RE: **Unser & Vista Oriente Paving
Grading and Drainage Plan
Engineers Stamp Date 2/15/17 (H10D006A3)**

Re: Unser and Vista Oriente Grading and Drainage Plan
Engineer's Stamp dated 3-11-08 (H10/D006A3)

**Re: Unser and Vista Oriente Grading and Drainage Plan
Engineer's Stamp dated 1-2-08 (H10/D006A3)**

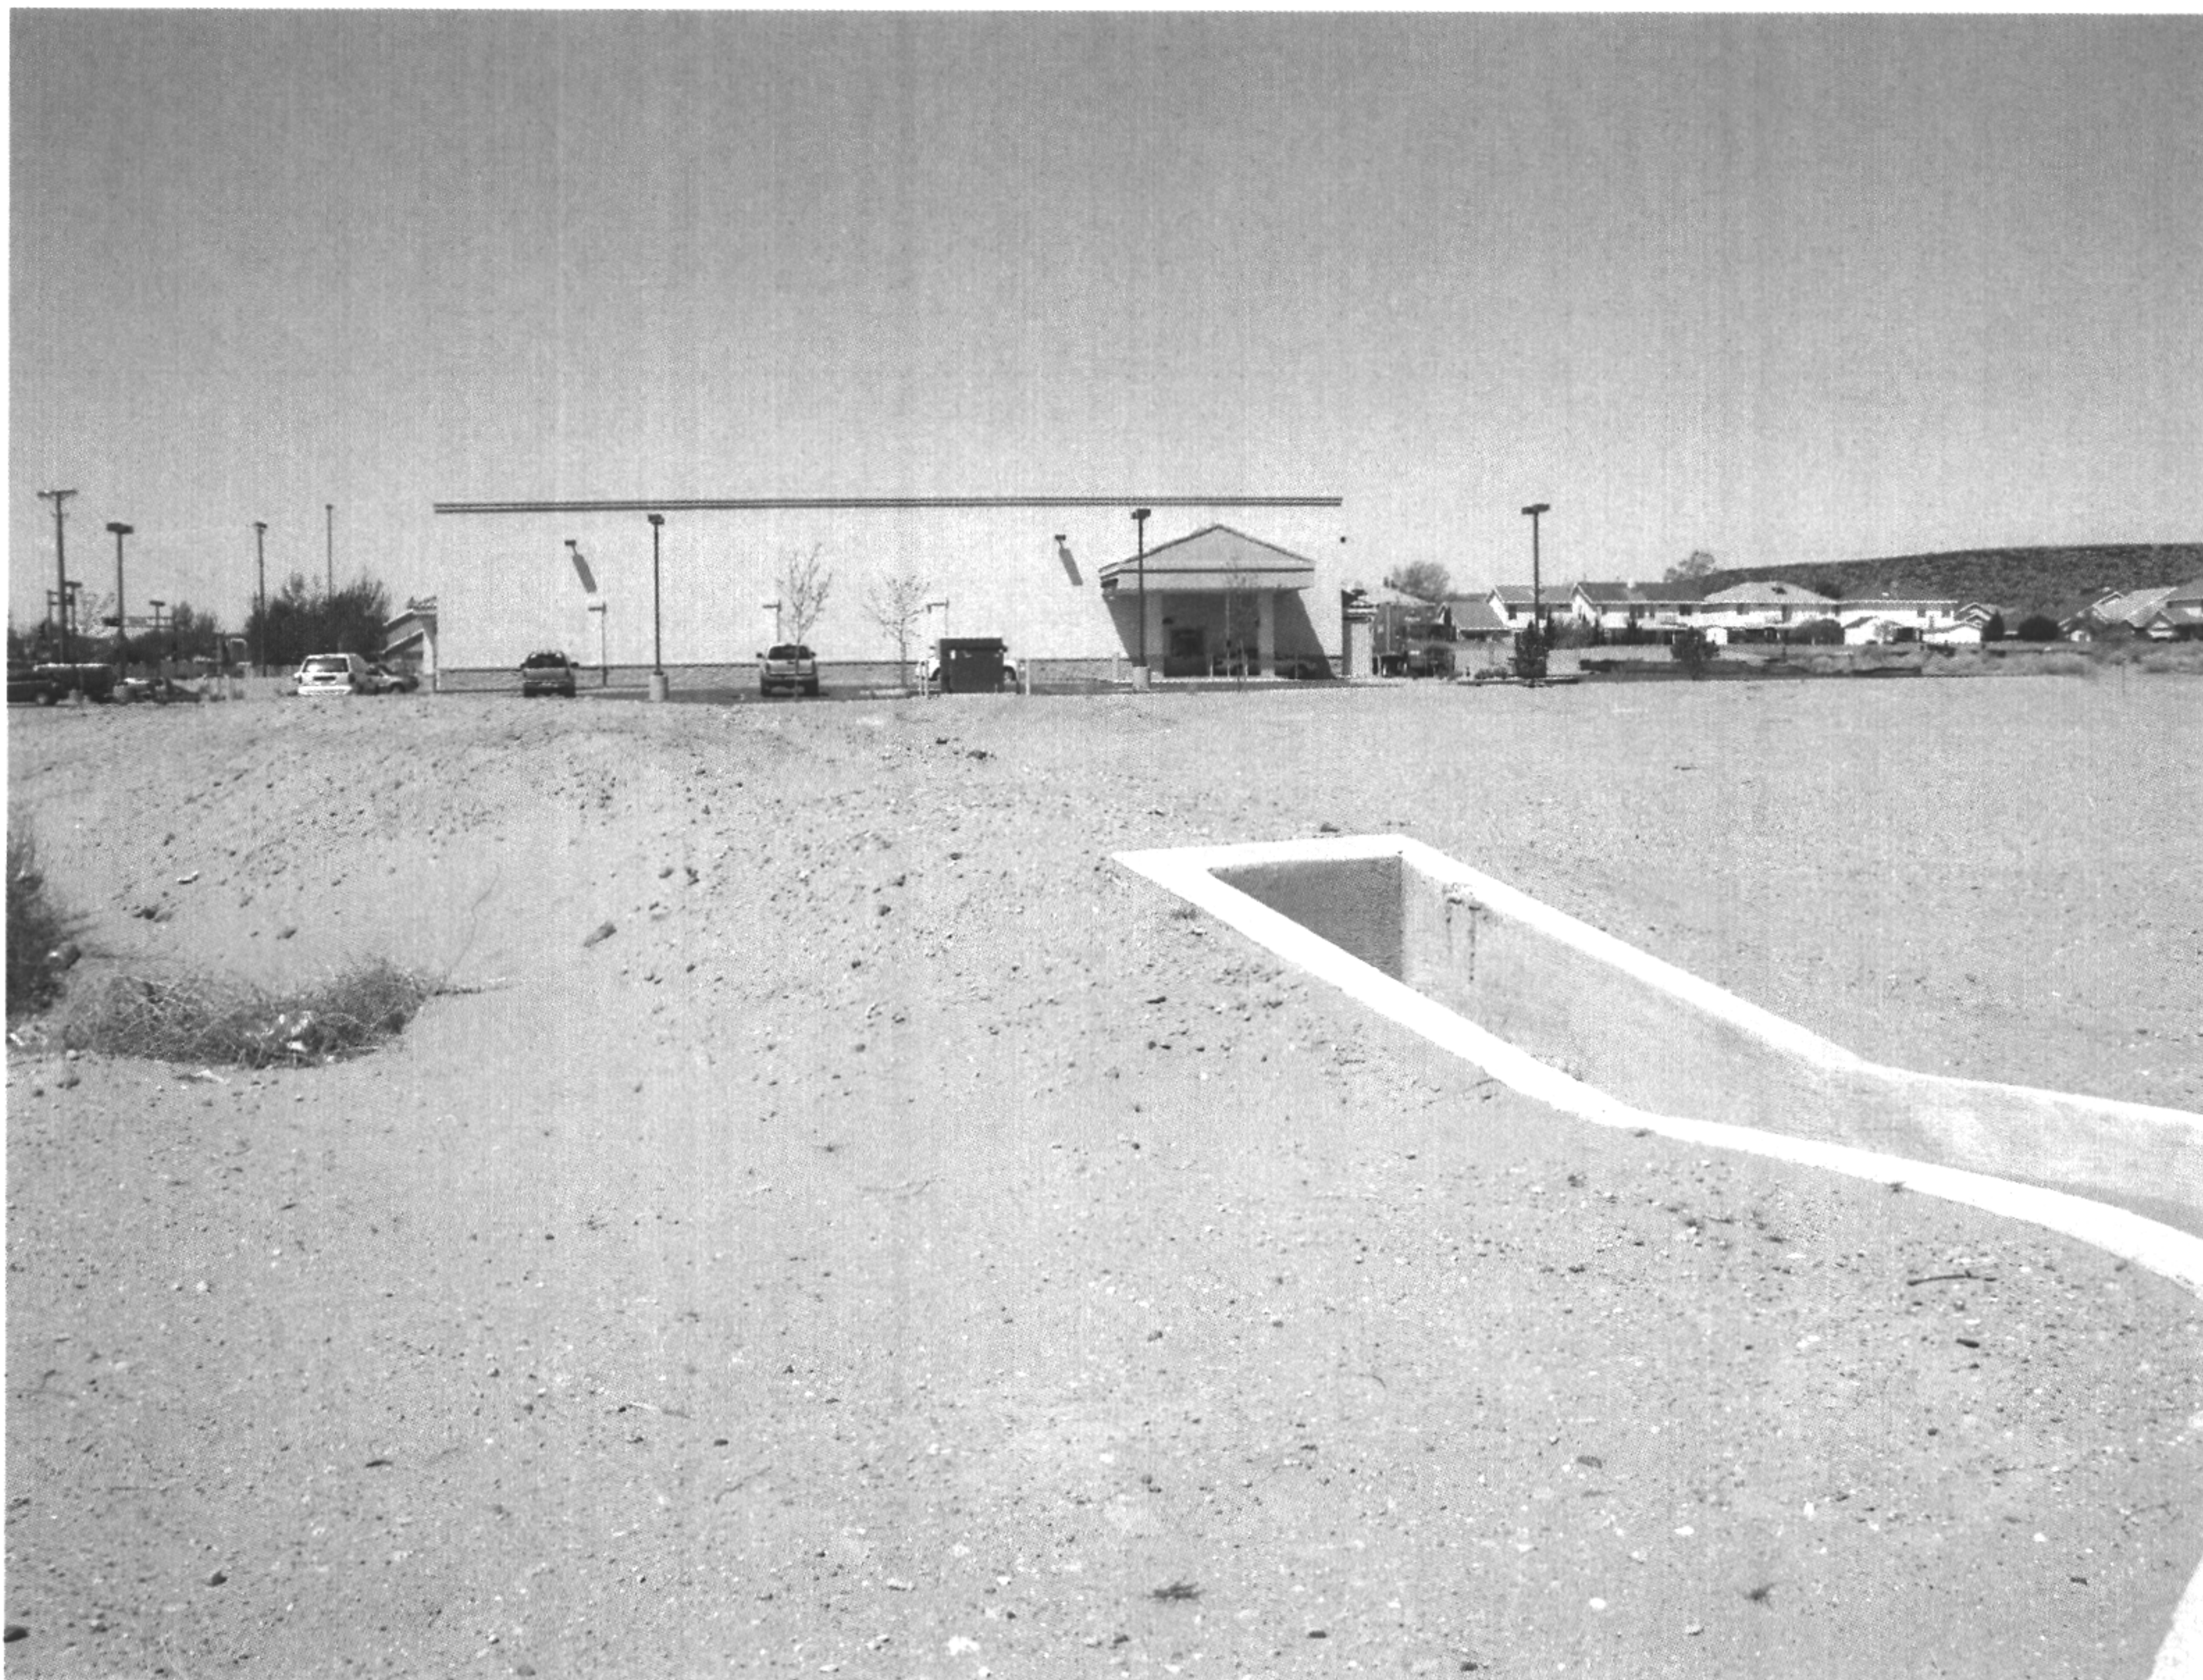
- The top of the 15" plastic storm drain in the drive entrance is approximately at 93.6. There does not appear to be enough cover over the pipe. The as-built plan shows the 15" line to be RCP, however, I visited the site and the storm drain is plastic.
- Provide grades on the walkway near the sidewalk culvert headwall. It appears there may be a conflict between the walkway and the 15" RCP.

- 1) The top of the 15" plastic storm drain in the drive entrance is approximately at 93.6. There does not appear to be enough cover over the pipe. The as-built plan shows the 15" line to be RCP, however, I visited the site and the storm drain is plastic.
The labeling was changed to reflect the HDPE material and the entrance was raised to provide enough cover over the pipe.
- 2) Provide grades on the walkway near the sidewalk culvert headwall. It appears there may be a conflict between the walkway and the 15" RCP.
The location of the pedestrian connection was changed to avoid any conflict with the pipe and provide a better ADA connection.
